Work Order ID 106714

Item Name: Radius Block

APICAL INDUSTRIES, INC.	ENGINEERING CHANGE NOTICE NO. 03697				SHEET 1 OF 1	
	DWG NO. 646.3800	REV: N/C	PREPARED BY B. PETERS	DATE: 11/14/12	EFFECT ON DWG <input type="checkbox"/> INC. <input checked="" type="checkbox"/> UNINC.	
	DWG TITLE: BRACKETS					
	APPROVED BY: ENGR <i>[Signature]</i>	MFG <i>[Signature]</i>	QC <i>[Signature]</i>	EFF: NEXT ORDER		
TRANSACTION CODES (TC) A-ADD C-CREATE R-REVISE D-DELETE	REASON: ADDED ALTERNATE MATERIAL.				ECR: D-12-006

SHEET 1, ZONE A2 IS:

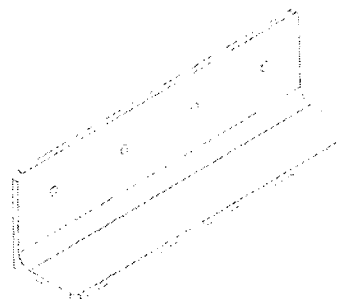
⚠ PRIMARY MATERIAL: 7075-T651 ALUMINUM PER AMS-QQ-A-250/12.
ALTERNATE MATERIAL: 7075-T6511 ALUMINUM PER AMS-QQ-A-200/11.
